For the attention of Jennifer Begeman, Case Officer

Planning Application No. 24/00078/HYBRID: Hybrid application: Full application for the erection of 120 No. dwellings (Use Class C3), including affordable housing, landscaping, public open space, allotments, ecological enhancements, SUDs and access. Outline application (with all matters reserved) for 0.25 hectares of land for a new Medical Centre (Use Class E(e)) with associated access, parking and landscaping. | Bassetts Farm Goudhurst Road Horsmonden Tonbridge Kent TN12 8AS

Figure 1: Map showing the adopted Limits to Built Development (source: HNP, 2023)

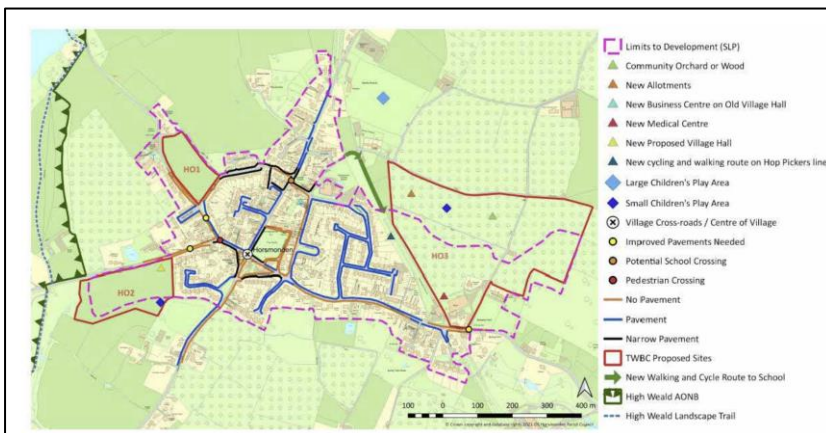
- 1.9. This statement is not wholly accurate. The site is not wholly included within the adopted LBD for Horsmonden. Rather it extends significantly north of the adopted LBD, particularly on the western part of the site.

- 1.10. The adopted LBD is not indicative, as is often referenced by the applicant. It has in fact been established in the HNP, as shown on *Figure 1* (the dotted pink line). It duplicates the LBD as shown in the TWBC SLP, which was informed by a series of evidence reports (see para 1.10) and has been adopted via the HNP in advance of the adoption of the SLP.

- 1.11. This adopted status is confirmed. The LBD was considered at the HNP examination where the extract (*Figure 2*) confirms that it has been defined by the HNP and hence forms part of the adopted development plan.

- 1.3. We would recommend the scheme is reviewed to restrict residential development to within the adopted LBD. This may require a reduction in overall housing numbers as discussed in Section 3 of this response.

Figure 3: Extract from the National Landscape (AONB) (source: AONB Setting Analysis Report, 2020)

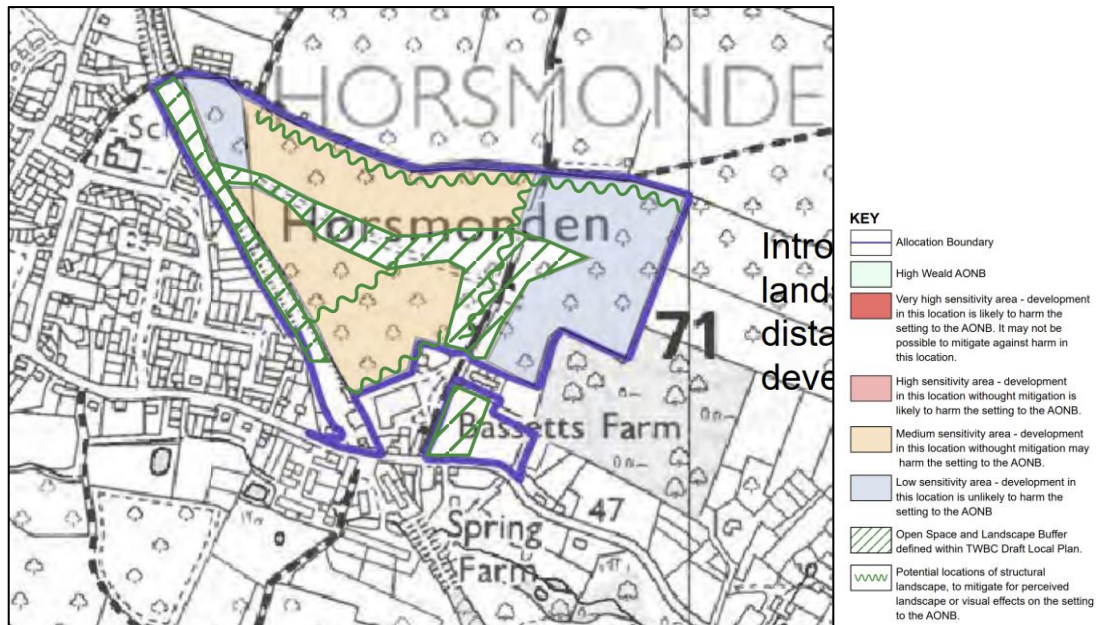
- [AONB Setting Analysis Report: supporting plans and photographs \(2020\)](#) – The northern areas of the proposed site allocation are considered to have medium sensitivity, meaning that development in this location without mitigation may harm the National Landscape (formally referred to as the AONB). The landscape buffer is shown on these maps (*Figure 3*).

Figure 5: Site allocation map for AL/HO3 (SLP)

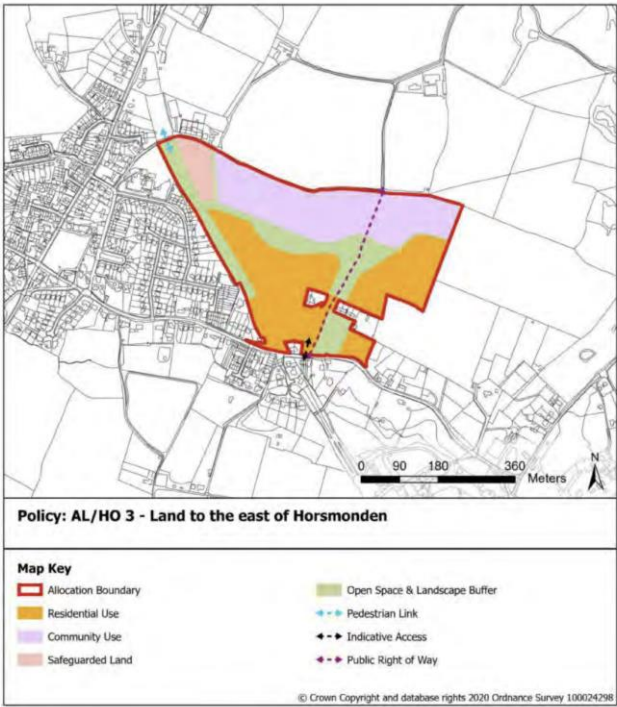
- 2.17. The location of the health centre was discussed at the [Local Plan Examination hearing session for Horsmonden](#) (that can be accessed from 2hrs:35mins) on 5 July 2022. Officers confirmed that its precise location was not finalised and that this would be done through the masterplanning of the site as part of the planning application process. The Inspector agreed with this approach, however, he advised that Policy AL/HO3 should be modified to state that the medical centre will be delivered within the orange Residential Use area, as shown on the site allocation map (*Figure 5*) and not within the purple Community Use area.

- 3.8. Moving the medical centre from the purple 'Community Use' area and into the orange 'Residential Use' area, as per the requirements of the site allocation policy and the advice of the Local Plan Inspector, would further reduce the footprint of the application site suitable for built development.

Figure 9: Significant views identified in the HNP (Views 6, 7 and 13)

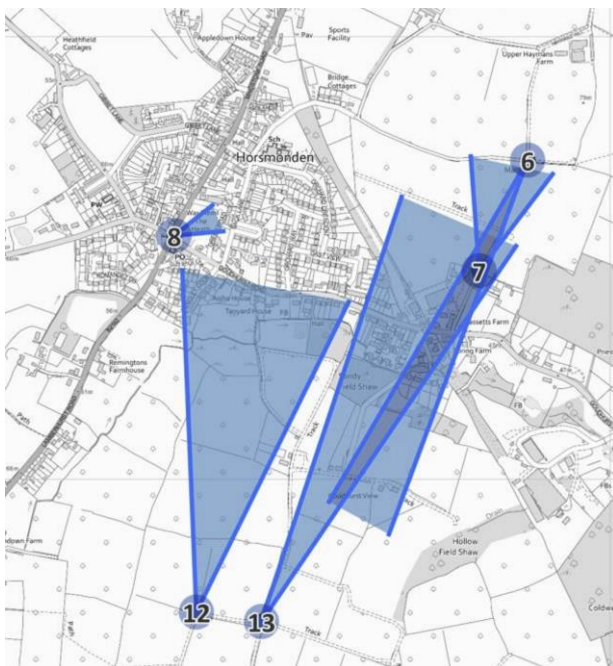
- 5.9. Policy 7.2 of the HNP seeks to protect important local views, stating: “Development must not cause any loss or diminution of historical or significant view into and out of settlements.” Aside from views onto the site from the High Weald National Landscape, for instance from Goudhurst, three significant views have been identified that need careful consideration within the design of the application (Figure 9). Views 6, 7 and 13 in particular include Bassetts Villas (non-designated assets) within their scope. The design of the scheme needs to be amended to take account of this.

Figure 10: Image showing area (within the oval area) where landscape buffer should be placed (left), as per SLP site allocation policy (right)

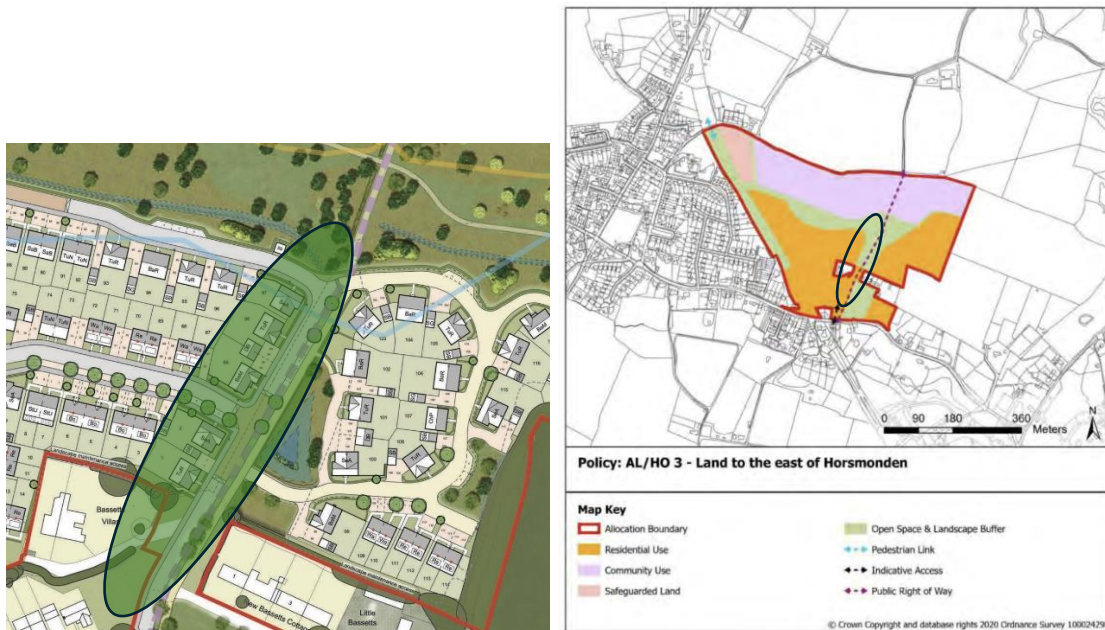
- 5.10. From a heritage perspective, the proposal seeks to site eight dwellings to the west of the footpath located to the east of Bassetts Villas, which are non-designated heritage assets. This is not in accordance with the site allocation policy in the SLP, which requires a landscape buffer in this location, to the west of the footpath. This is shown on Figure 10. The plans should be amended to incorporate this buffer, which would assist in preserving the setting of those heritage assets.
